Docket Item #24-A & B
DEVELOPMENT SITE PLAN #2004-0008 (B)
SUBDIVISION #2003-0011 (A)
RENAISSANCE CUSTOM COMMUNITIES, LLC

Planning Commission Meeting
May 4, 2004

ISSUE: Consideration of a request for a development site plan and subdivision for construction of three single family detached homes at the northwest corner of Russell Road and Lloyds Lane.

Site Plan with Conservation Area

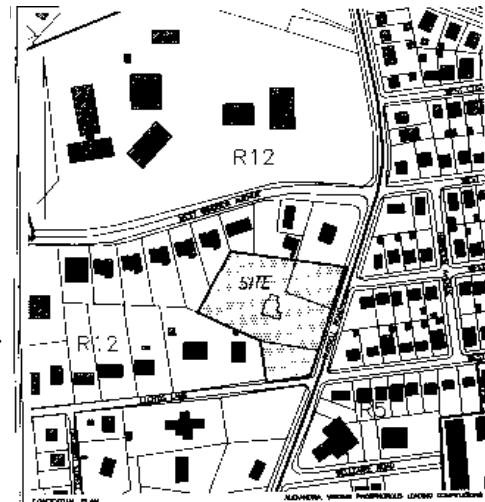
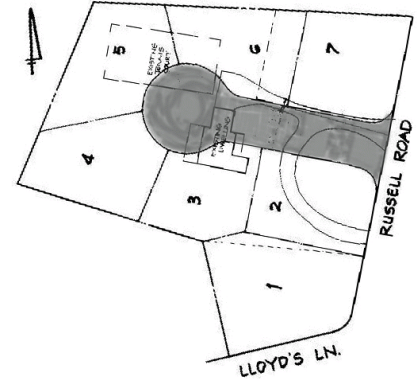
Area of proposed conservation easement

The applicant is also proposing a 15,862 sq.ft. conservation-open space easement at the corner of Russell Road and Lloyds Lane. The current proposal retains 79% of the site, retains most of the existing trees and proposes four less units than are permitted with the current R-12 zoning.

Location of Lot 903:

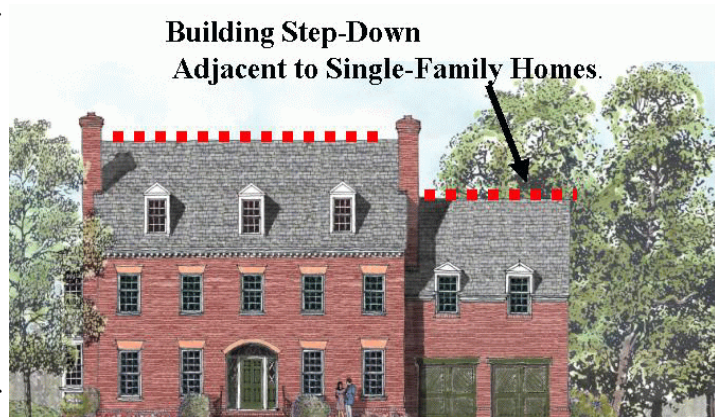
Several adjoining residents have raised concern that the home for lot 903 should be relocated to increase the setbacks to the adjoining single-family homes.

The home as depicted in this graphic is adjacent to the rear property of two homes on Windsor Avenue. Staff is recommending a significant amount of additional landscaping and other measures in an attempt to mitigate the concerns that have been raised by the adjoining residents.

This house was located by the applicant to minimize the loss of trees, grading, additional impervious surface and to retain the existing large trees. The proposed home is approximately 80 feet from one of the adjoining homes on

the northwestern portion of the site, and 43 feet from the closest home. The proposed house complies with the minimum setback requirements within the zone. To address the concerns that have been raised by the adjoining residents, staff is recommending that the applicant provide a significant amount of additional evergreen and deciduous landscaping/screening on the site as well as on the adjoining properties. The site of the proposed home is several feet lower (approximately 3-6 ft.) than the adjoining single family homes, which helps to mitigate the height of the proposed building. The house cannot be located farther away from the adjoining homes due to the considerable topography on the southern portion of the site. Relocation farther south would result in the elimination of mature 25" and 27" caliper trees on the site. The applicant has stated that they are unable to locate the house farther south due to the topography, soils and the fact that they believe the house would no longer be marketable because the front of lot 903 would effectively be facing the rear facade of lot 902.
